FLOATING-POINT HARDWARE ACCESSORY KIT

UPDATING SUPPLEMENT FOR OPERATING AND SERVICE MANUAL

Manual Serial No. Prefix: NA
Manual Printed: JAN 1972
Manual Part Number: 12901-90001

SUPPLEMENT DESCRIPTION

Figure 4-1. ROM Control Card (with Floating-Point), Parts Location Diagram

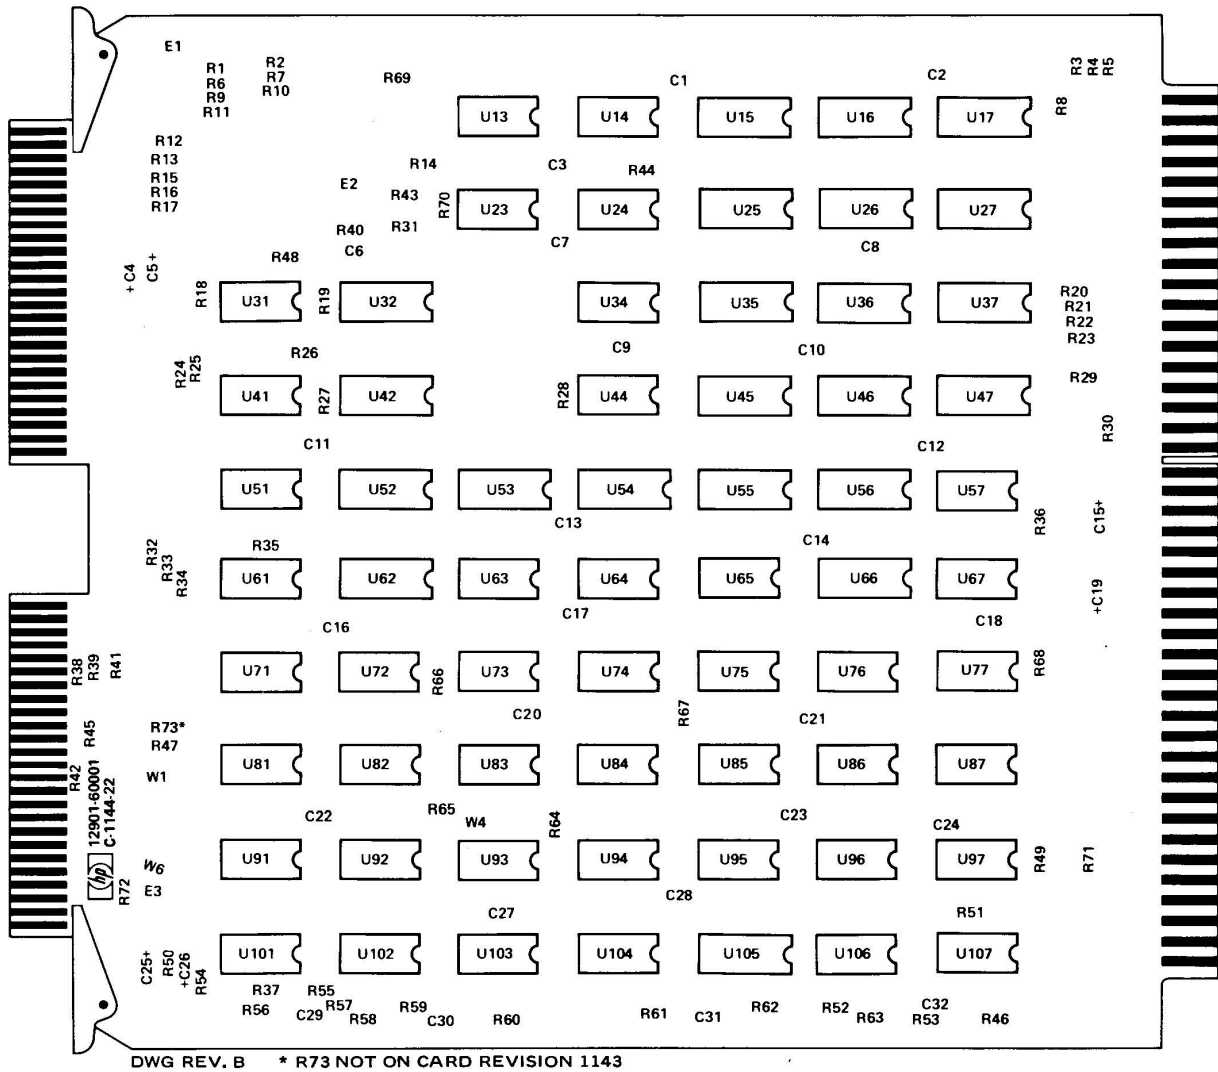
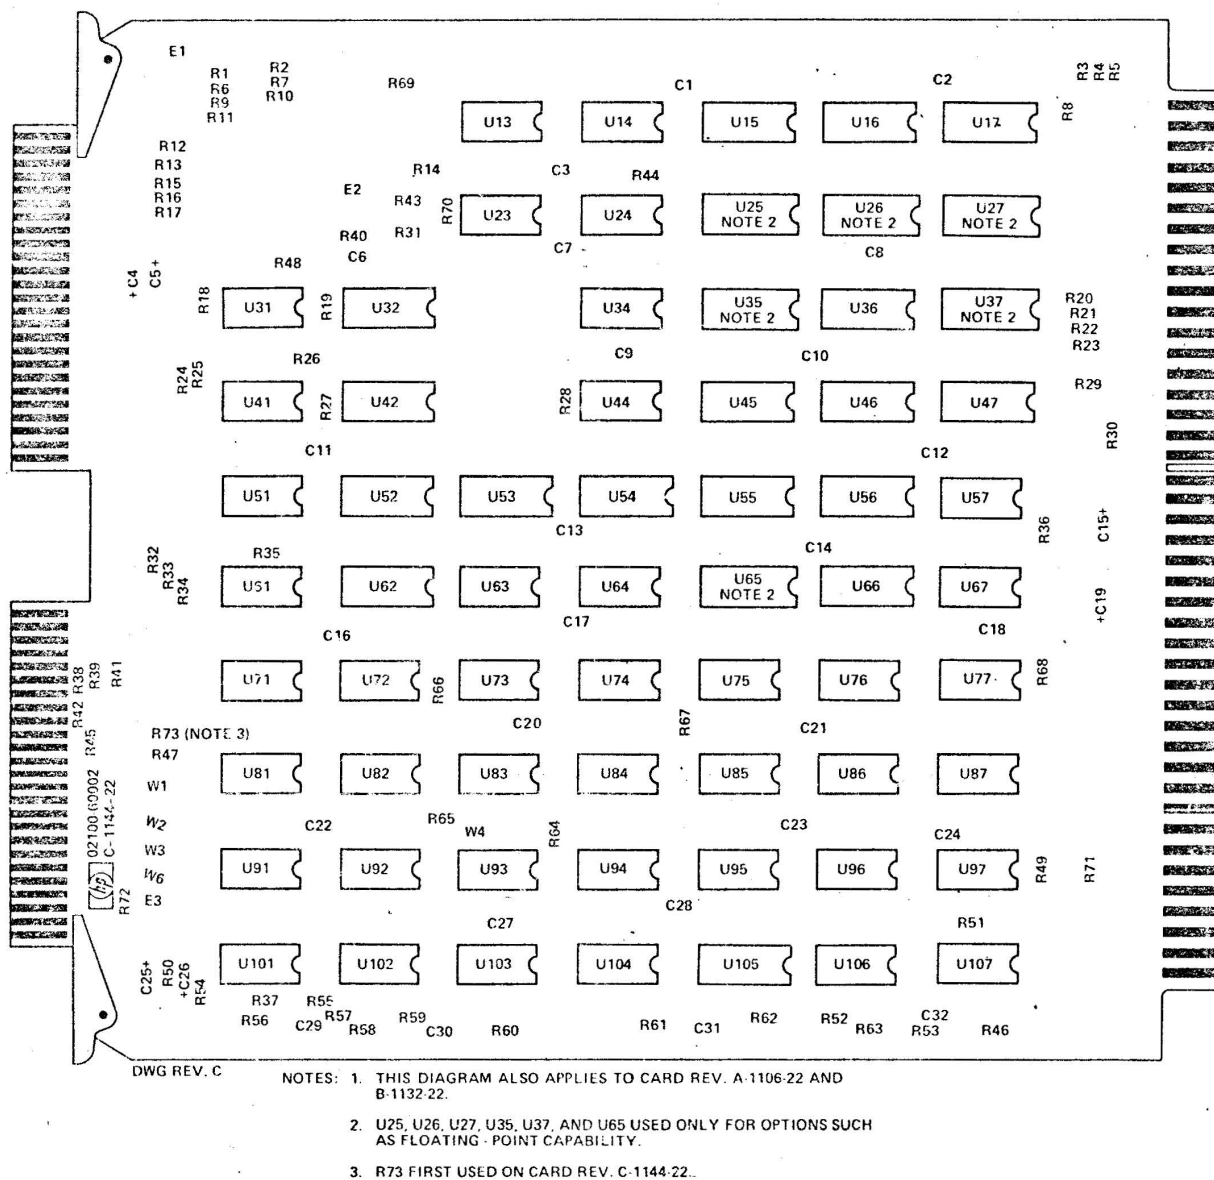
- 8 Page 4-6. Replace figure 4-1 of the manual with figure US-1 of this supplement.
